MEMO

Subject: Kerikeri Model Update & Reruns

Pungaere 1961m to 6200m	Conflicting levels in this section of the river	Levels typically consistent within 0.1m
----------------------------	--	---

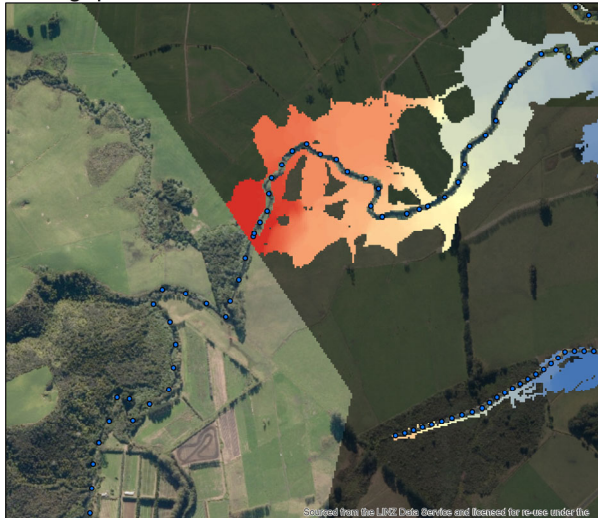
NRC identified the Lake Manuwai and Pangaere Stream branches to be of particular concern in regard to water level results, with differences of up to a 1 metre noticed between the 1D and 2D 100yr results. With the additional lateral link segments, and adjusted depth tolerance parameters, re-running the 100yr simulation produced 1D/2D water levels that were typically within a 0.1m range. The 50yr and 10yr results showed similar consistency.

To address the issue of lateral link skewing, numerous lateral links were broken into smaller lengths, with particular attention paid to confluences and meandering segments. The original model contained 222 distinct lateral links, while in the updated model there are now 342.

Figure 1: Flood results hitting upstream model boundary

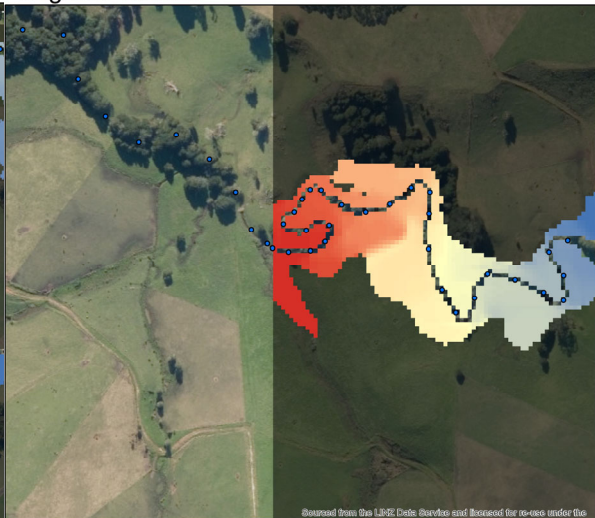
Two areas of concern in the model still remain which relate to the model schematisation. The first is at the upstream end of the Maungaparerua Stream and the Pungaere Stream where the floodplain extends to the model boundary, Figure 1. Because of this the model may be overpredicting water levels at these two locations and care should be taken when interpreting results in these areas. The other point of concern is at the downstream boundary where the 2D model does not include an outflow boundary, all water is instead bounded by the MIKE 11 model. This area would operate better if the 1D model ended with a standard link to the 2D and the tide boundary was controlled solely by the 2D model. Alternatively, the 2D coastal boundary may not need to be explicitly modelled and all flow could be directed into the 1D model and this used as the sole boundary instead. We do not believe that these issues will have significant implications to the model results, however it is recommended that these could be improved the next time the model is updated.
